REMARKS

Patent
S.N. 09/642,911
6822/62934

FIG. 16

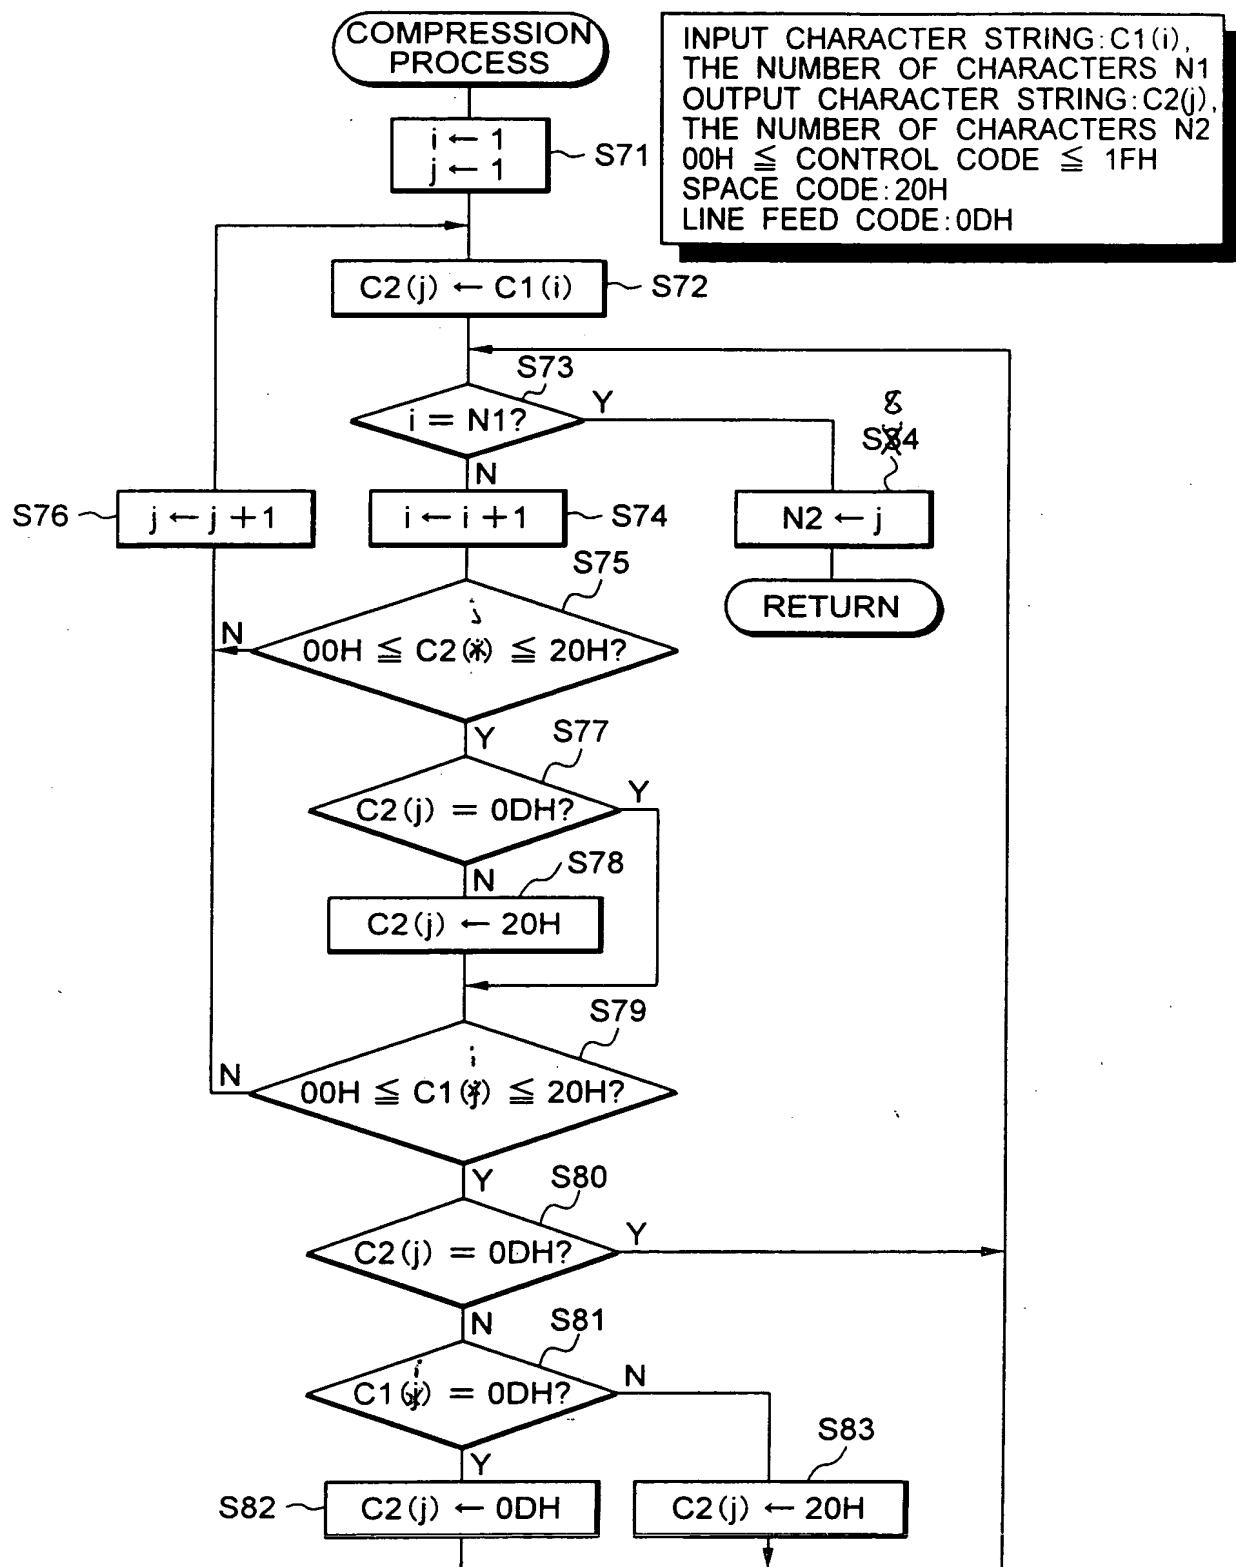
The attached sheet of drawings includes the following changes to Fig. 16:

"C2(i)" is changed in S75 to "C2(j)";

"C1(j)" is changed in S79 to "C1(i)";

"C1(j)" is changed in S81 to "C1(i)";

"S34" is changed to "S84".
